ALTERNATIVES / IMPACTS / WORKING GROUP RECOMMENDATIONS

US 113 North / South Study

May / June 2005

Milford Area - Preliminary East Bypass Alternatives

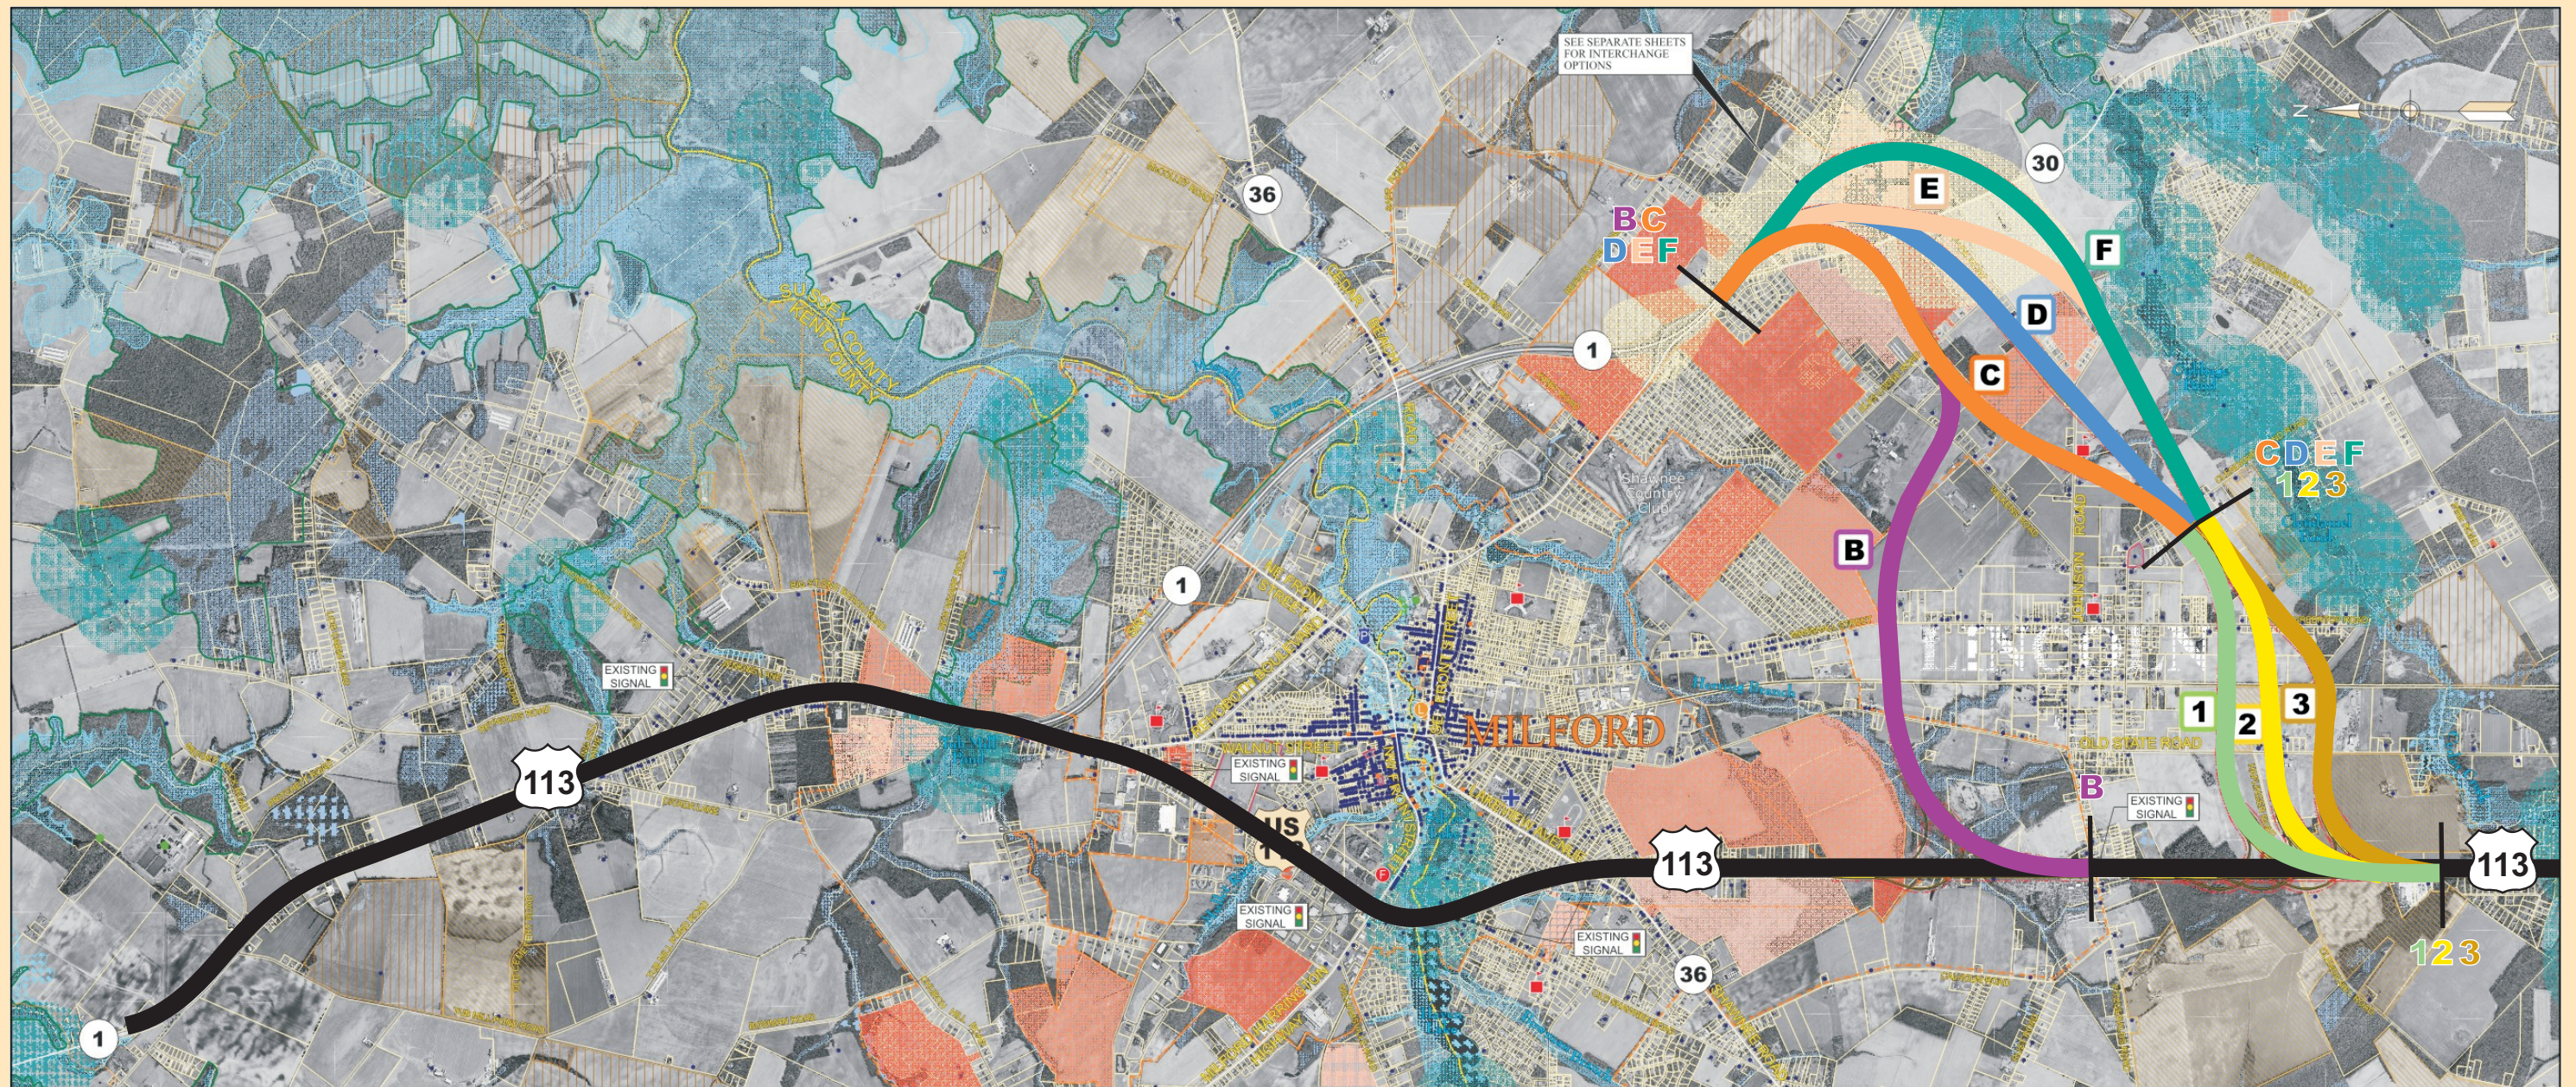
- There was consensus among the Working Group members to recommend to DeIDOT that Alternatives B, C, F, 1 and 3 NOT be retained for further consideration.
- There was consensus among the Working Group members to recommend to DeIDOT that Alternatives D2 and E2 be retained for detailed study with the additional recommendation to adjust the alignment of D and E to minimize impacts and to adjust 2 in the direction of 3 as necessary to minimize impacts.

- All eastern bypasses will reduce traffic on US 113 in Milford.
- All have limited resource impacts compared to the western bypasses.
- Alternative B is longer and affects more aquatic resources than Alternatives C through F.
- Of the 84 public comments received on the eastern bypasses at the last workshop, 57 were positive. Sections F and 3 received the most public support, C and 1 the least.
